LAND USE APPLICATION SUMMARY

Property Location: 2701 Bloomington Avenue
Project Name: 2701 Bloomington Avenue New Storefront Building
Prepared By: Shanna Sether, Senior City Planner, (612) 673-2307
Applicant: Erdogan and Yildiz Akguc
Project Contact: Erdogan Akguc
Request: To construct a new commercial storefront building.
Required Applications:

Variance	To reduce the minimum front yard setback along Bloomington Avenue from 20 feet to 4 feet.
Variance	To reduce the off-street parking requirement from 6 spaces to 2 spaces.
Variance	To reduce the minimum drive aisle to allow for maneuvering in the public alley.
Site Plan Review	For a new commercial storefront building.

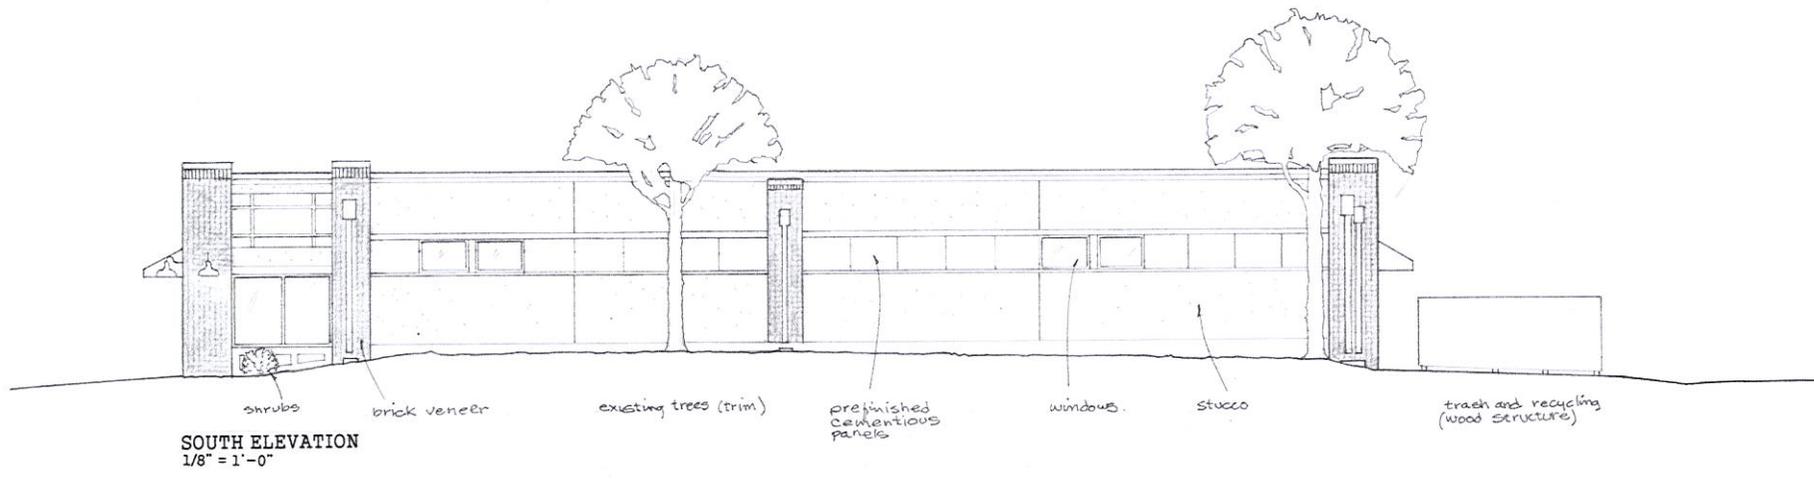
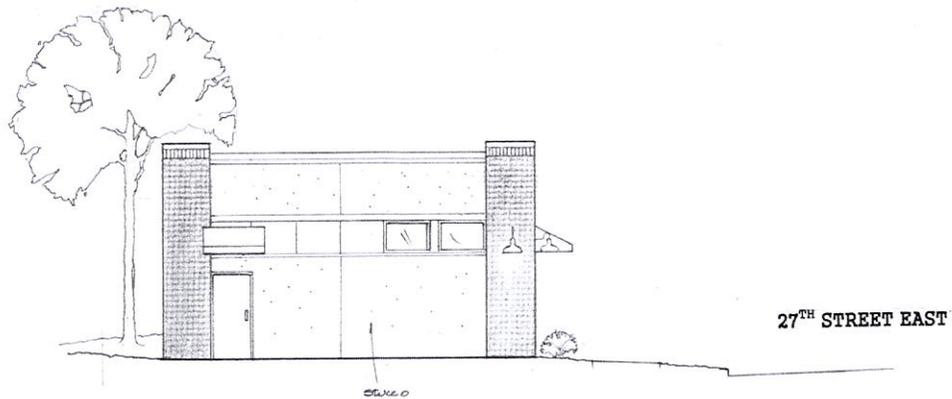
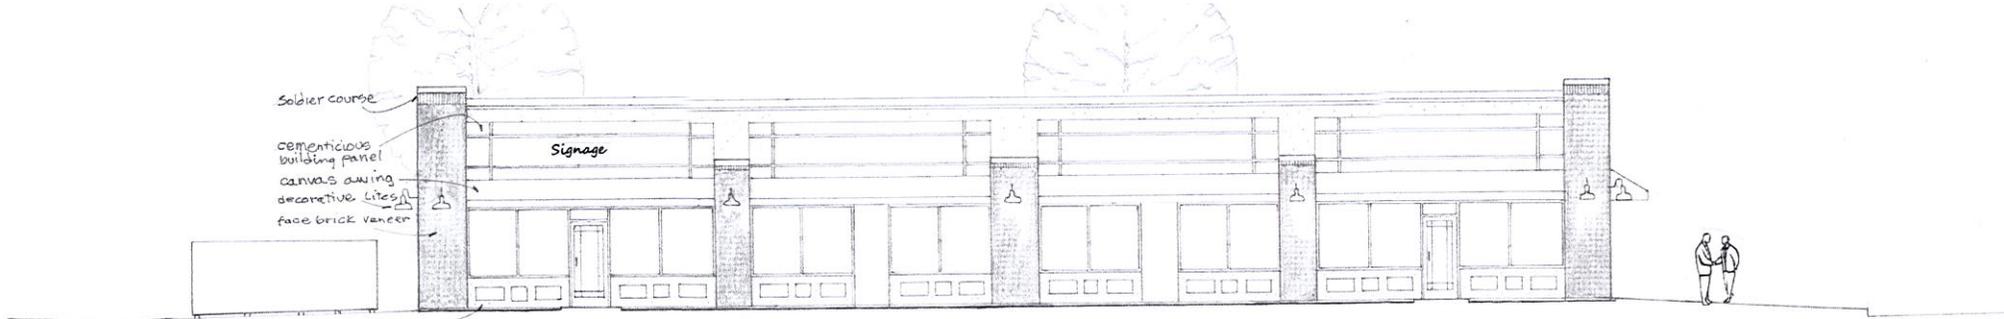
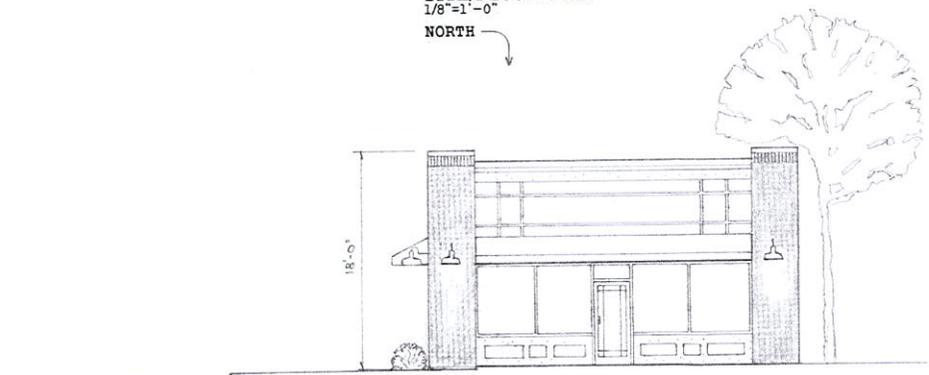
- The applicant is proposing brick, stucco, and cement panel accents as the building’s exterior materials. Each elevation would comply with the City’s durability standards for exterior materials (see Table 2). Please note that exterior material changes at a later date may require review by the Planning Commission and an amendment to the site plan review.
- In addition, the application is consistent with the City’s policy of allowing no more than three exterior materials per elevation, excluding windows, doors, and foundation materials.
- Plain face concrete block is not proposed along any public streets, sidewalks, or adjacent to a residence or office residence district.
- The exterior materials and appearance of the rear and side walls of the building are similar to and compatible with the front of the building.

- For nonresidential uses, the zoning code requires that no less than 30 percent of the walls on the first floor are windows with clear or lightly tinted glass with a visible light transmittance ratio of six-tenths (0.6) or higher. The project requires alternative compliance to the minimum window requirement (see Table 3) facing the on-site parking. The applicant has stated that there are security concerns with locating windows at the pedestrian level on this façade. There are proposed windows on the rear elevation, facing east, however they do not meet the requirements for location to be counted. Staff is recommending that the planning commission grant alternative compliance to this requirement.
- Each individual ground level tenant complies with the minimum window requirements.
- All windows are vertical in proportion and are evenly distributed along the building walls.

SITE/FLOOR PLAN
1/8"=1'-0"
NORTH

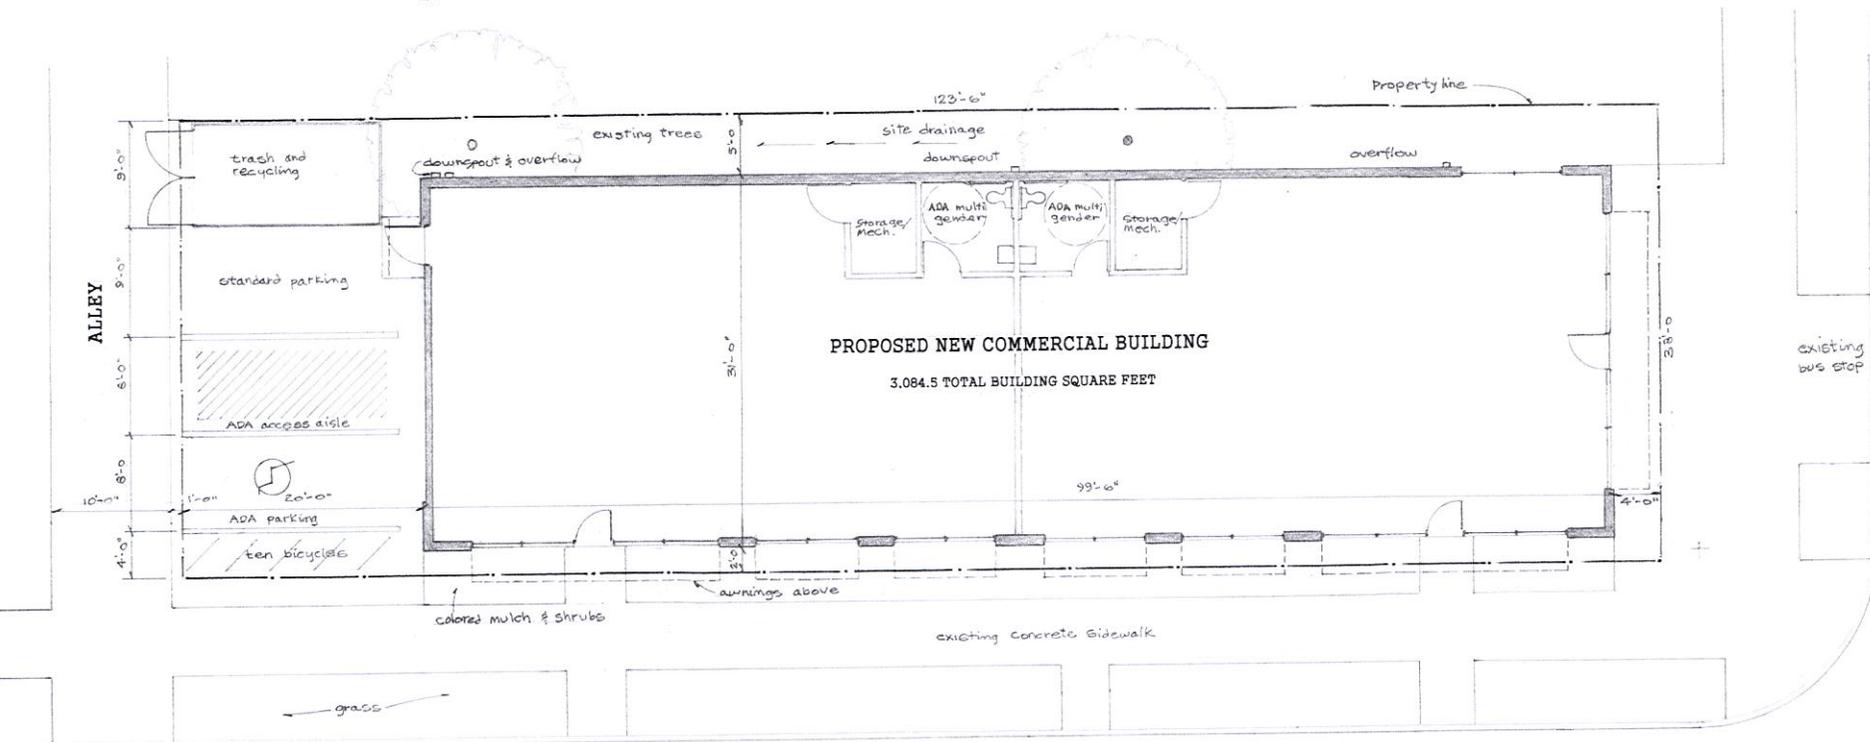
- The applicant is proposing at least one shrub per 100 square feet of the required landscaped area, including all required landscaped yards. The shrub requirement for the site is 4 and the applicant is proposing 0 shrubs. Staff is recommending that the applicant provide a minimum of four shrubs.

- The parking area facing 27th St E does not contain an on-site landscaped yard, where at least seven feet in width is required. The applicant is requesting alternative compliance due to the lack of lot width to provide a trash enclosure and two off-street parking spaces. Staff is recommending that city planning commission grant alternative compliance to the minimum landscaped yard requirement and redesign the parking area in the following manner: provide the bicycle parking in the right-of-way, with permission by the city engineer, relocating the trash enclosure outside of the

- The applicant is not proposing a three-foot screen between the parking area and the public street. Staff is recommending that the applicant provide screening between the parking area and the public sidewalk, consisting of a masonry wall, fence, berm, hedge, or combination thereof that is at least 60 percent opaque.

- The parking area abutting or across the alley from a residence district and residential uses is required to contain an on-site landscaped yard of at least seven feet in width. There is sufficient area to provide a five-foot landscaped yard between the parking area and the adjacent residential property; however it would be impractical to provide landscaping along the alley. Therefore, staff is recommending that the planning commission grant alternative compliance to reduce the required landscaped yard from seven to five feet along the south property line and from seven to zero feet along the alley.

- The applicant is required to provide a six-foot screen that is at least 95 percent opaque for the parking lot area facing the residential district or use. The applicant has shown the trash and recycling enclosure between the parking area and the adjacent residential property to the south. The enclosure is located within the side yard setback and will be required to a minimum of 5 feet from the property line; staff finds that the enclosure will provide adequate screening.

- Note to the Applicant: Applications for Sidewalk Cafés are reviewed and approved through Business Licensing; all references to the proposed sidewalk café (including tables) shall be removed from the site plan.

- Per the Minneapolis Code of Ordinances, out-swinging doors are permitted to encroach a maximum of 4" into the Public right-of-way. The Applicant should consider designs that provide for in-swinging doors or recessed doorways to prevent out-swinging doors beyond the maximum allowable encroachment.

- Remove vehicles and parking dimensions from the plans, as these are all in the Public right-of-way and are not reviewed during this process.
- City ordinance states that all maneuvers associated with loading, parking or sanitation pick up for a private development shall occur on private property. Please provide a narrative explaining the trash removal and delivery operations for all truck type vehicles that will be using the site. A Solid Waste Collection Point (SWCP) shall be identified on the site plans; per City Ordinance (Section 2, Ch. 225, Article V - 225.750. Solid waste collection point (SWCP):

- Permanent construction, such as the stoop foundations, is not permitted beyond the property line as shown.
- Doors are not permitted to swing across the property line as shown.
- Plans will also need to be certified by a MN licensed structural engineer at the time of building permit application.
- Handicap parking access aisles are to be marked "no parking" per 502.4.4 ANSI A117.1 2009
- Maximum slope 1:48 for access aisle and parking space per 502.5
- Aisles to be 96" (8') width 502.4.2.
- Maximum slope of exterior accessible routes is 1:20

3. CPED staff shall review and approve the final site, elevation, landscaping, and lighting plans before building permits may be issued. The applicant shall provide a minimum of 20% landscaping, one canopy tree and four shrubs.

4. The plant materials, and installation and maintenance of the plant materials, shall comply with sections 530.200 and 530.210 of the zoning code.
5. The applicant shall move the proposed trash enclosure out of the required interior side yard or completely within the enclosed building.

6. The applicant shall provide screening of at least 6 feet in height and 90% opaque between the parking lot and the adjacent residential property to the south and a landscaped yard of at least 5 feet in width.

7. The applicant shall provide screening of at least 3 feet in height and 60% opaque between the parking lot and the public sidewalk to the north.
